# **BID ADDENDUM 01**

Project: ROSEWOOD MIDDLE SCHOOL PHASE #1 Date: August 29<sup>th</sup>, 2024

## WAYNE COUNTY PUBLIC SCHOOLS ROSEWOOD MIDDLE SCHOOL ADDITION

EARLY SITE DEMOLITION - PHASE 1
ADDENDUM #1
AUGUST 28, 2024

Refer to Sheet C-2.0 Existing Conditions & Demo Plan

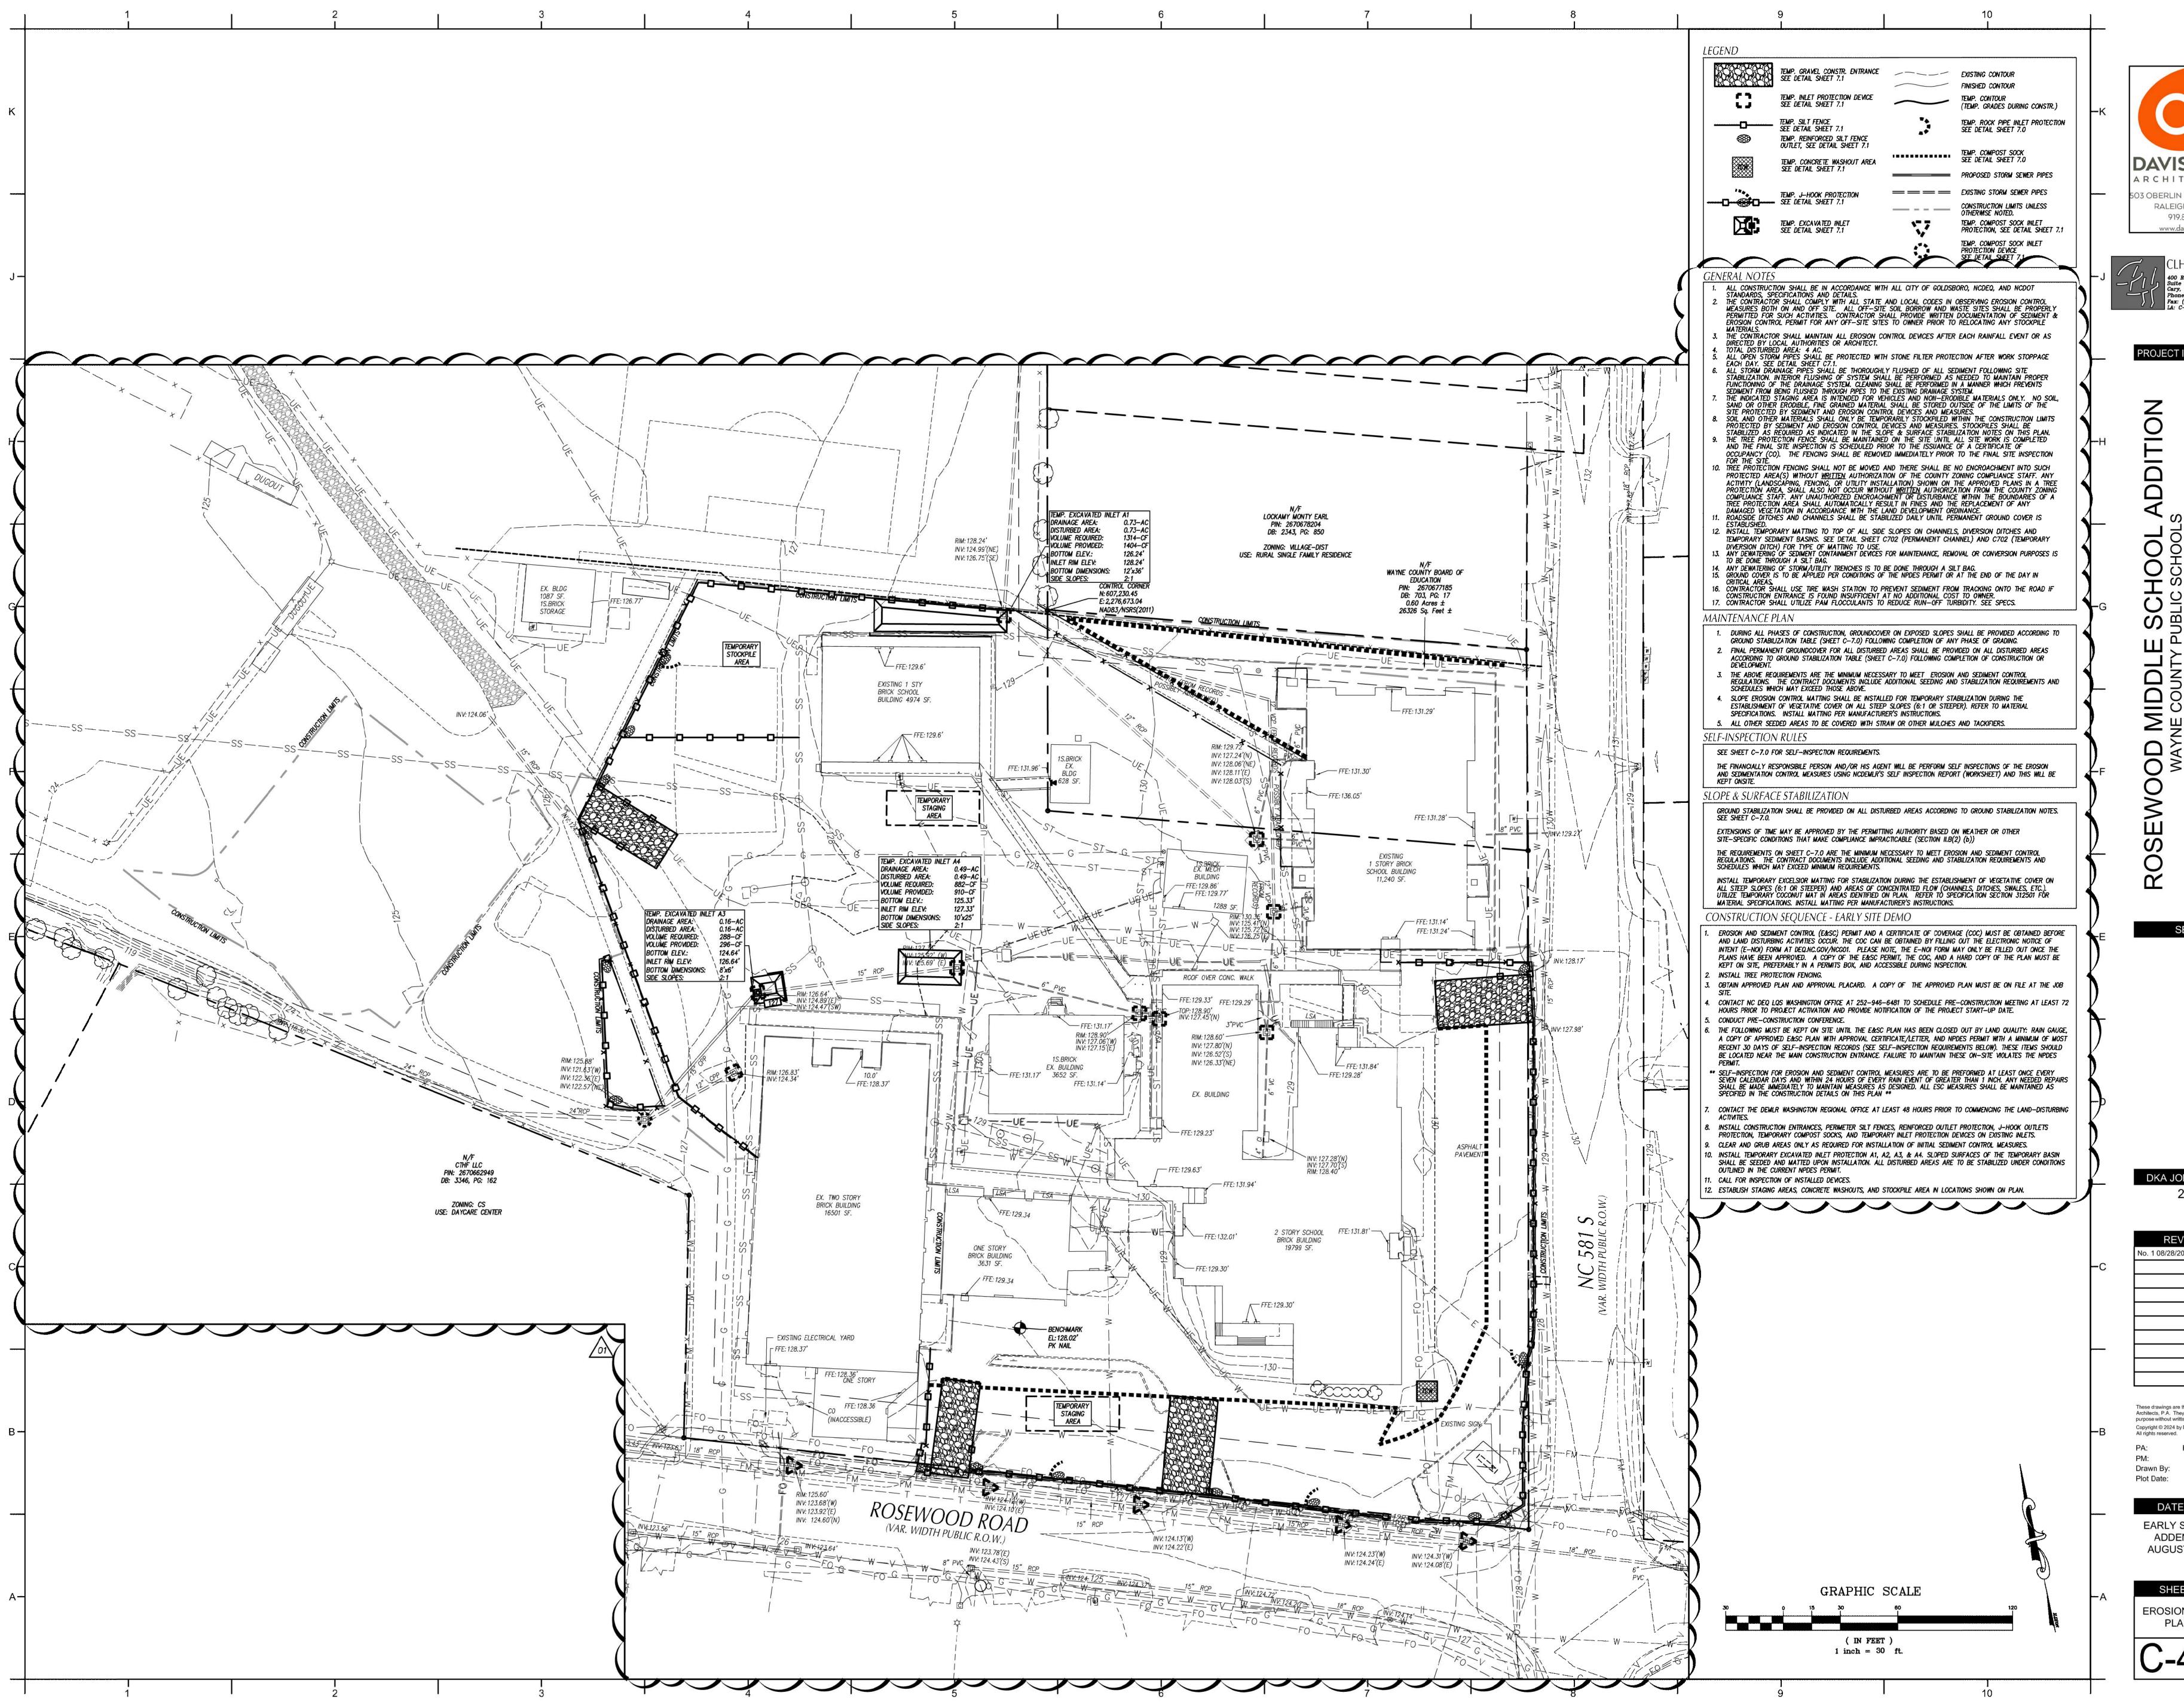
- 1. Refer to Legend, "Building/ structure to be removed. See Architectural Plans." Text has been removed
- 2. Refer to Key Notes:
  - a. "Remove 181 LF of Fence" has been removed from Key Notes
  - b. "See Architectural Plans for Gymnasium Entrance Demolition" has been removed from Key Notes
- 3. Extent of asphalt to be removed has been revised on the southern and western sides of the existing school building
- 4. Approximate location of covered walkway installed by Wayne County Public Schools shown on plans

SHEET TITLE SITE, GRADING &

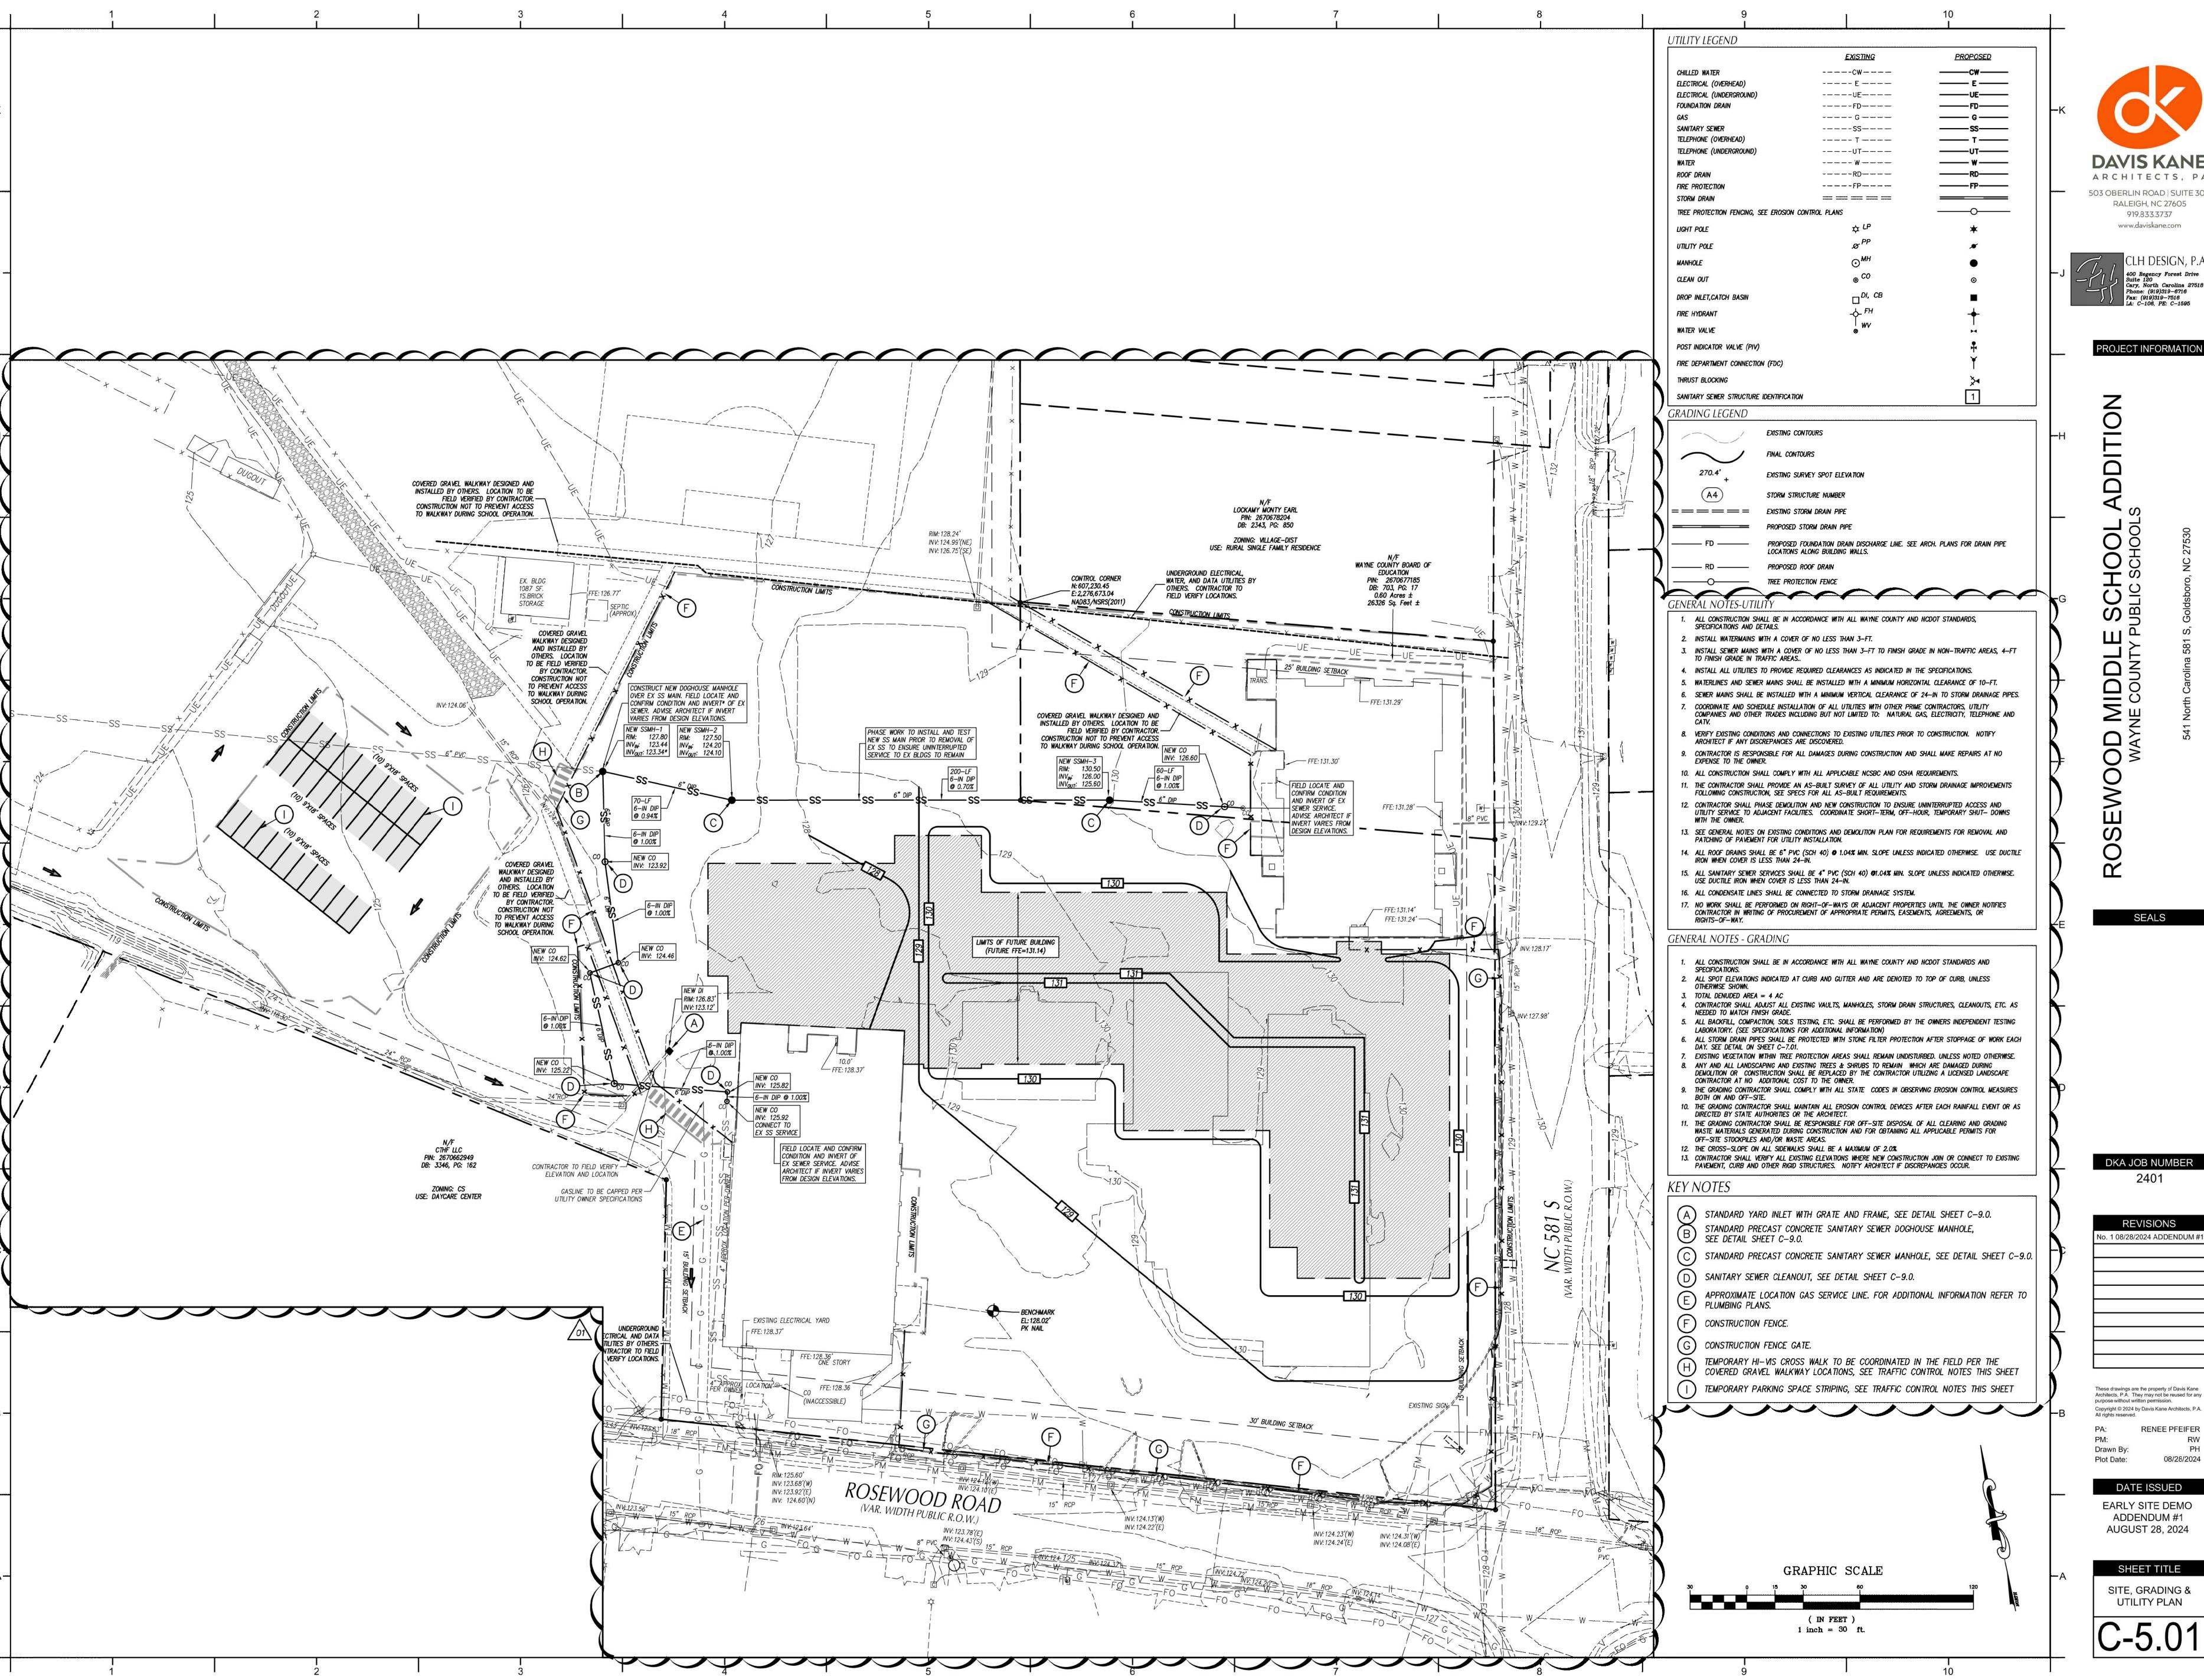
- 1. Sanitary Sewer routing has been revised
- 2. Approximate location of covered walkway installed by Wayne County Public Schools shown on plans
- 3. Pavement Marking Directional arrows have been added to plans for temporary traffic during construction
